Access Compliance Report

Public Rights-of-Way (Curb Ramps)

Intersection ID: N/A	Main Street: MILLENNIUM_AV	Cross Street: AUDUBON_PARK	Location: W
ADA ID: 12E2EC615790	Ramp Type: Perp	Initial Pass/Fail: Pass	Overall Compliance: No
Codes/Mitigation Info/Possible Solution		Field Measurements/Component Compliance

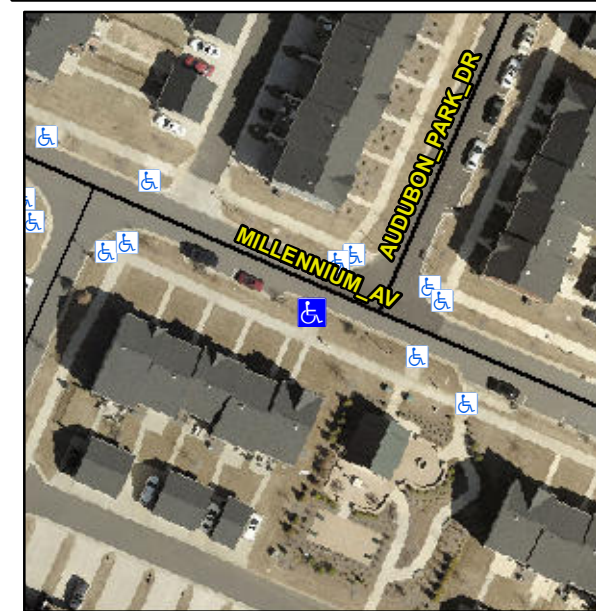
**Not Found, R304.5.3, R305.2,
R304.5.4**

**Remove & Replace Entire Ramp.
Remove & Replace Gutter.**
